**TITLE:** [PR-CM] Development Application DA10/0222.26 for an Amendment to Development Consent DA10/0222 for Casuarina Town Centre Including 56 Lot Subdivision, Road Works, Infrastructure Works and Landscaping (Department of Planning Application MP06\_0258) MOD 10 at Lot 15 DP 1198266 Casuarina Way, Casuarina

This report has been prepared to provide Council with an overview of staff comments in relation to the proposed modifications to the approved Concept Approval and Project Approval for the Casuarina Town Centre development (MP06\_0258).

**That Council endorses the comments to be submitted to NSW Planning & Environment with regard to all proposed modifications of the Concept Approval and Project Approval relating to Casuarina Town Centre (MP06\_0258) MOD 10.**

**Figure 6: Proposed Allotment Layout**

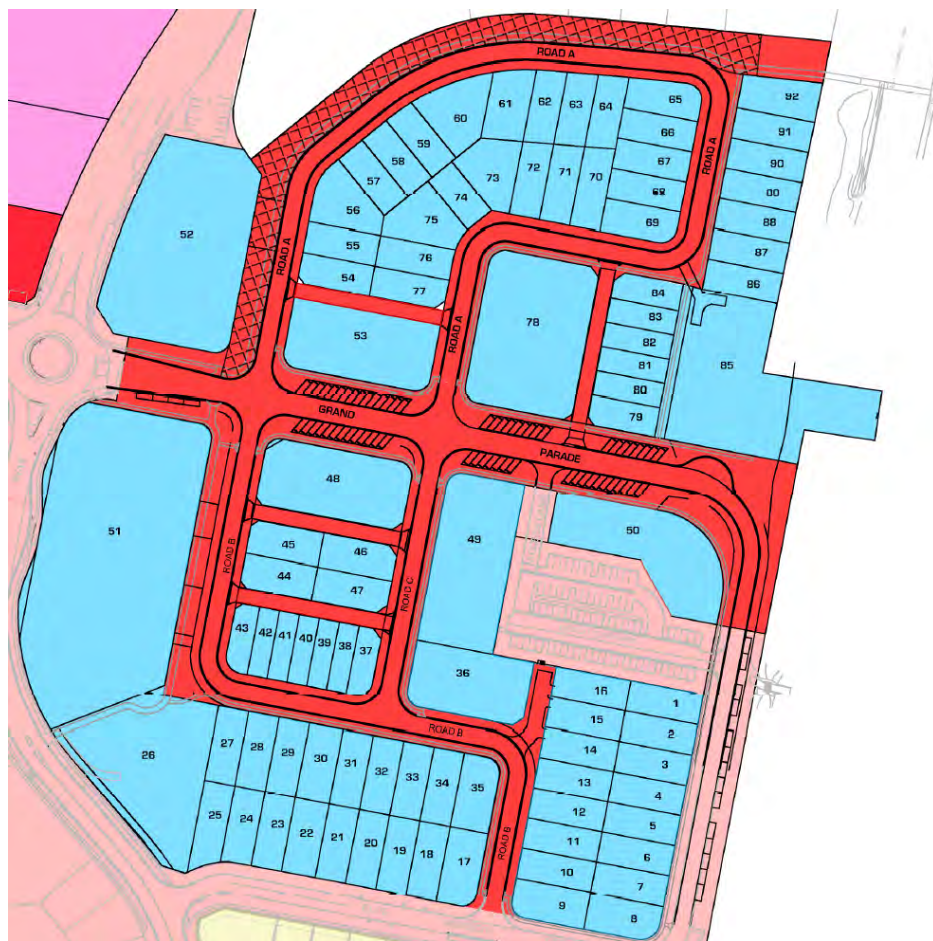
Concerns are raised with respect to the extent and number of retaining walls proposed under the modified layout. Council’s Development Engineering Unit has advised the following with respect to this;

- Concerns are raised on the number of retaining walls proposed across the site. It seems that the applicant has used multiple retaining walls to provide flatter gradient sites. The previous earthwork approvals did not have multiple retaining walls and still achieved compliant gradients.
- Concerns are raised regarding the number of proposed retaining walls in public road reserves / open space foreshore area on the eastern boundary. The walls would attract increased maintenance issues such as graffiti, re-painting, weed control etc... compared to a gradient batter that is grassed. The previous earthwork approvals did not have multiple retaining walls.

Figure 7: Proposed Layout (North)

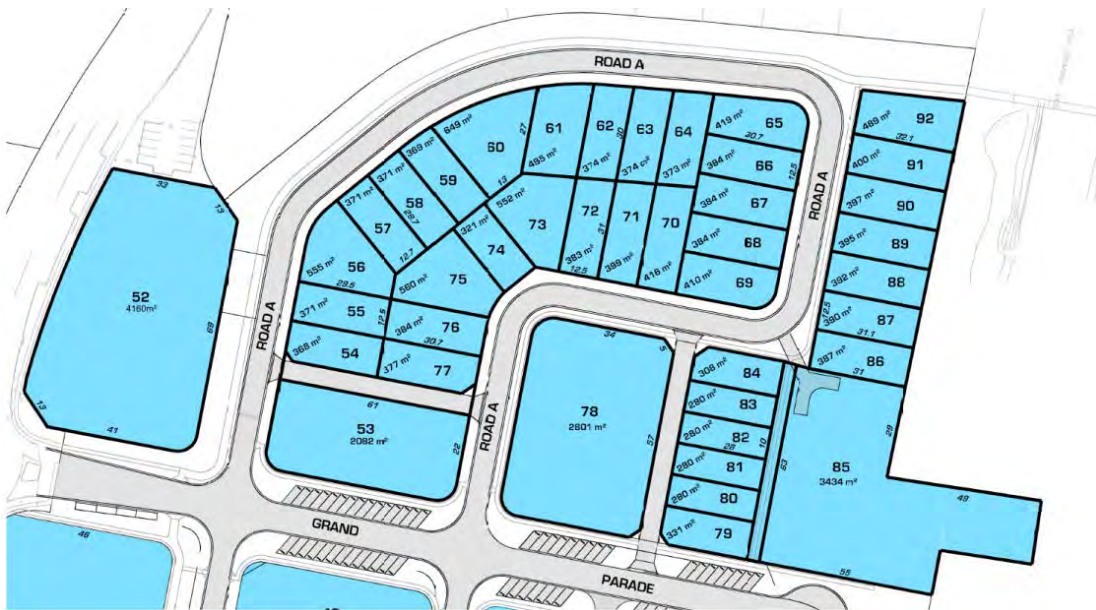
*The proposed 4 leg intersection treatments at Grand Parade/Roads A and B, are not considered acceptable given Council’s experience with similar intersections where crash history results in required upgrading through Federal Black Spot funding. The traffic volumes need review in accordance with the RMS Guidelines and suitable treatments constructed (roundabouts) to reduce potential conflict points. Roundabouts also provide turnaround facilities for motorists seeking on road parking negating the need to circulate on residential roads or Casuarina Way.*

*The on road parking layout on Grand Parade is only suitable for left in movements. The parking bays should be modified to be 90 degree angle parking with dimensions according to AS2890.5.*

- *The current approval provides roundabouts at four way intersections. The proposed modification now seeks to provide four way intersections with Give Way signs by means of priority control with Grand Parade. The applicant justifies intersection design to be Give Way by argumentation of low traffic volumes, more friendly towards pedestrians and cyclists at four way intersections. The applicant has not considered Tweed Shire Councils Specifications for design.*

- *An access lane is proposed to connect the beach car park to Grand Parade. The proposed access lane is almost directly opposite a proposed driveway access for proposed Lots 79 – 84. Australian Standard AS2890.1 specifies prohibited locations of access driveways (Figure 3.1). The proposed driveway access as indicated is within the prohibited location.*

**Figure 13: Approved Easement**

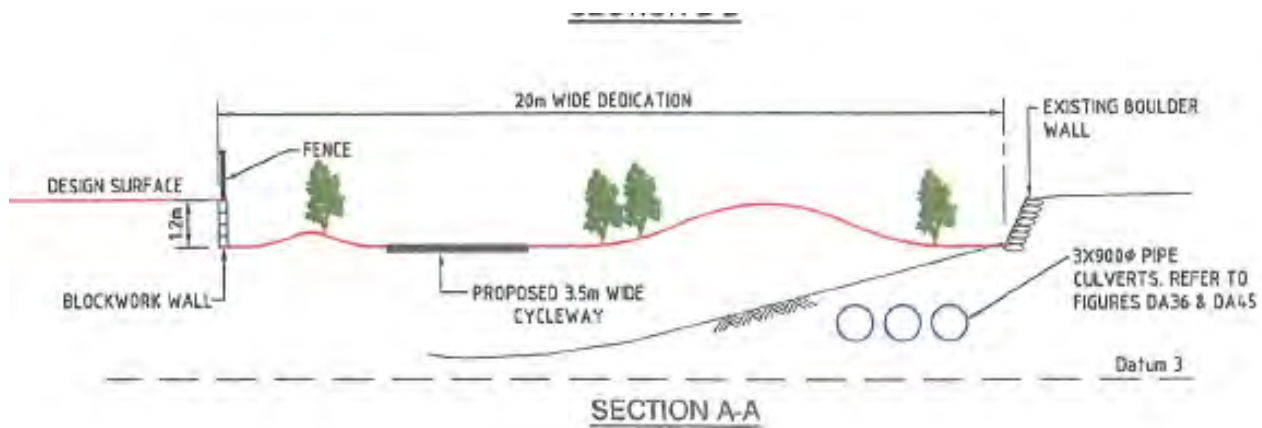
*The drainage swale provides a high capacity connection between the coastal swale that services the Casuarina Estate and an outlet to Cudgen Creek to the west. It provides a high degree of infiltration due to the sandy soil. Taking into account the design specifications provided by the existing consent and Council's D5 specification, the modification application proposes to replace the open swale with large diameter pipes (3 x 1650mm pipes) to cater for the Q100 flow. Modelling demonstrates that this piped configuration does not increase upstream flood levels in extreme events, or increase the incidence of the coastal swale overtopping the dune to the beach. This would allow for the overall easement width to be reduced, provided equivalent infiltration can be achieved elsewhere in the trunk drainage system. As such, there is no hydraulic reason to oppose the piping of the swale drain, only the public benefits afforded by the wider easement.*

**Figure 15: Concept drawing of proposed 8m wide buffer**

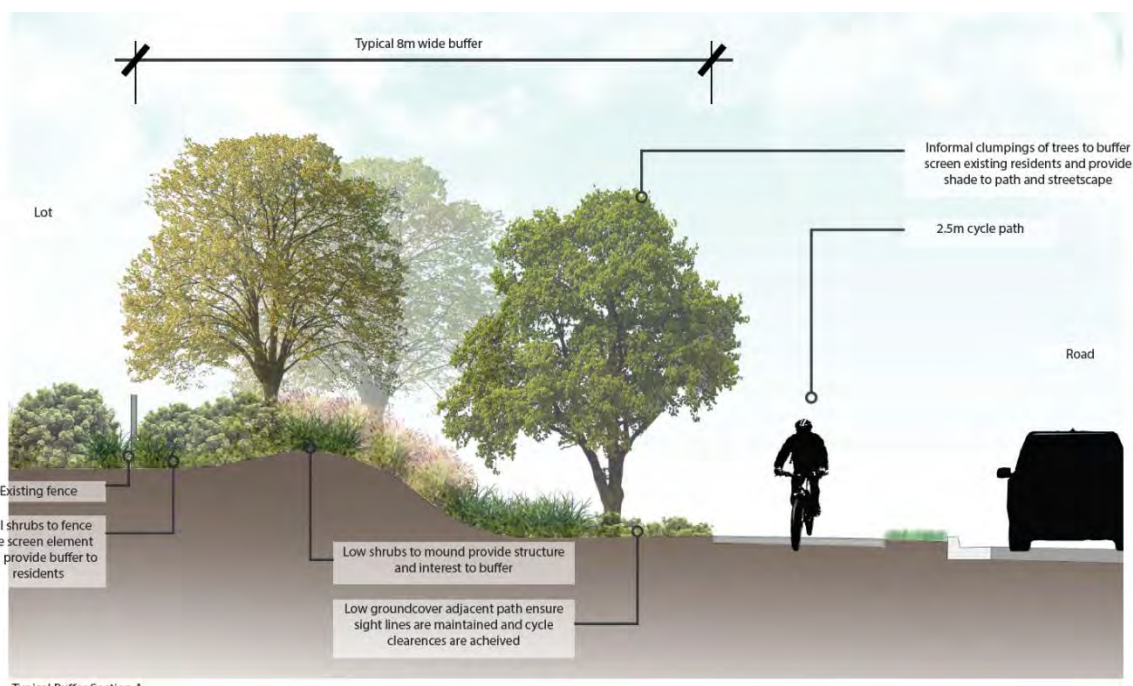
*Detail of the proposed configuration of the area within the easement is difficult to locate in the modification application. It is assumed that the area will be dedicated as a widened road reserve, containing landscaped vegetation for the first 8m from the northern boundary, a 2.5m wide cycleway, and then a local access street, up to the front boundary of low density residential allotments. The 3x1650 stormwater pipes, a realigned sewer, as well as necessary water services, telecommunications and street lighting will be provided within this area.*

*It is requested that the applicant provide a clear cross section showing all above and below ground infrastructure, landforming batters and retaining structures, and clearances between the various uses e.g. Vegetation, cycleway, roadway, verge widths, and piped infrastructure. Without such detail, it is suspected that inadequate width has been allowed for in the design, noting that approved 20m wide drainage reserve in the current approval did not include road infrastructure.*

Council would request that the Department of Planning & Environment give consideration to the public submissions received with respect to this element of the modification and it is considered that without sufficient justification for a change to the approved layout, Council would prefer that the existing arrangement remain to this area.

Figure 16: Proposed Staging plan

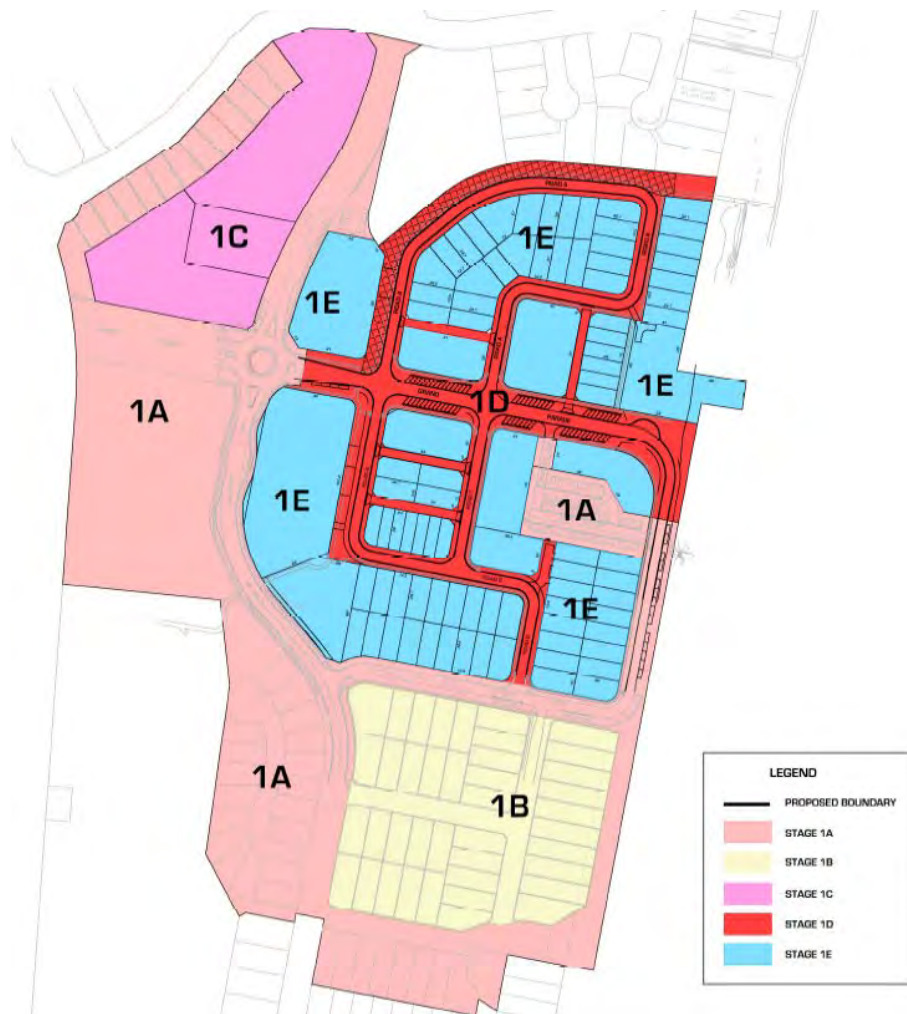
Council do not have any specific objections to the staging of the development in this manner, provided the provision of infrastructure (Stage 1D) occurs prior to the release of allotments (Stage 1E).

It is noted that Development Sequence Plan (Drawing No. 13/054), prepared by Newton Denny Chapelle and dated 21 December 2015 demonstrates an allotment to the west of Casuarina Way as part of Stage 1D works. The Department of Planning and Environment are requested to clarify whether it is intended to incorporate this site into Stage 1D works.

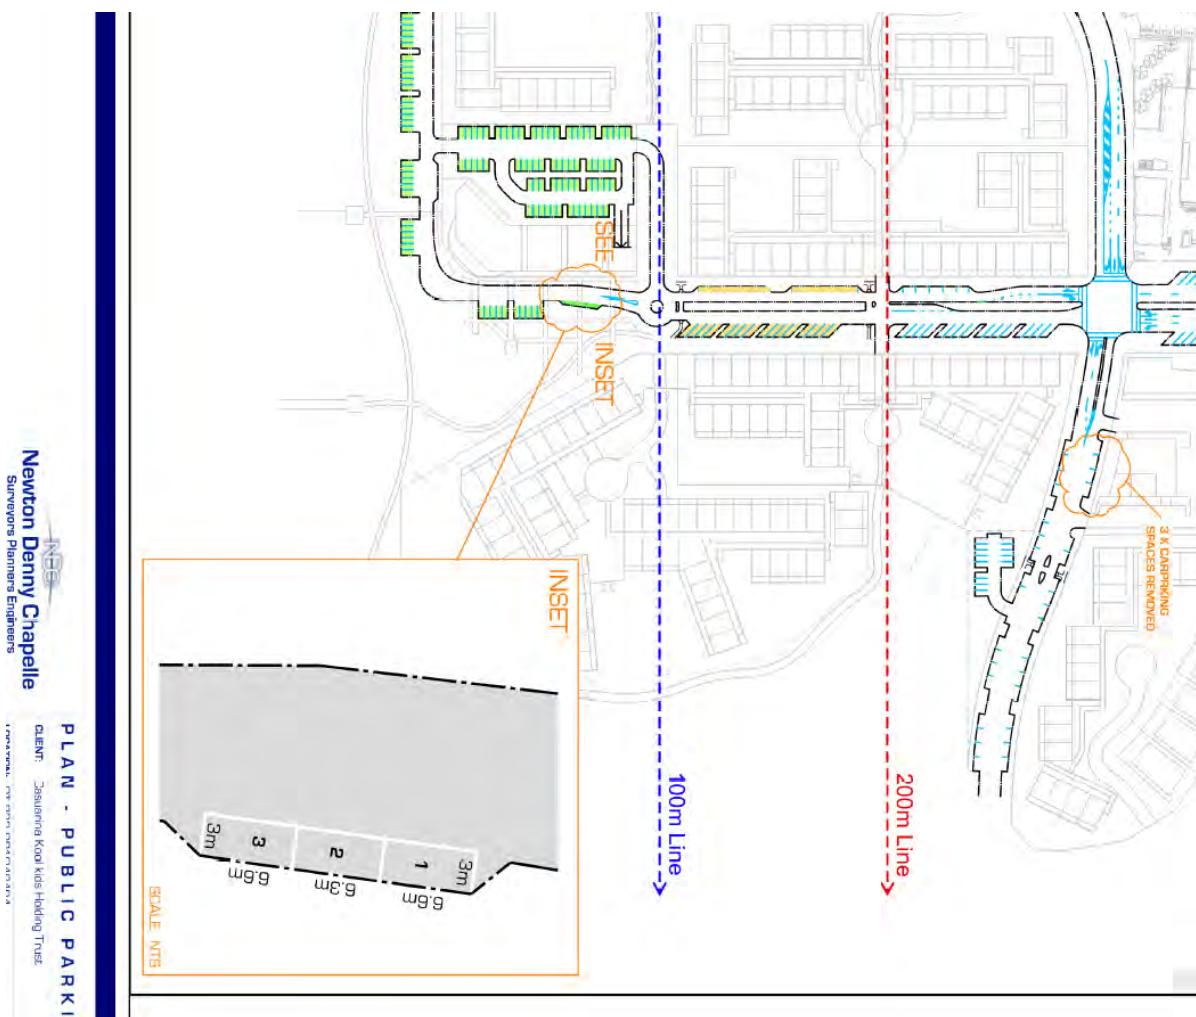
- The existing approval includes a proposed 3.5m wide cycleway connecting from Casuarina Way to Casuarina foreshore along an easement of various widths. In addition the approval provides an additional cycleway connection to Casuarina Way near the existing Santi building.

The proposed modification now seeks to reduce the proposed cycleway width from 3.5m to 2.5m and delete the additional cycleway connection to Casuarina Way near the existing Santi building. The cycleway width of 3.5m and cycleway connection to Casuarina Way near the existing Santi building is to remain as per approved.
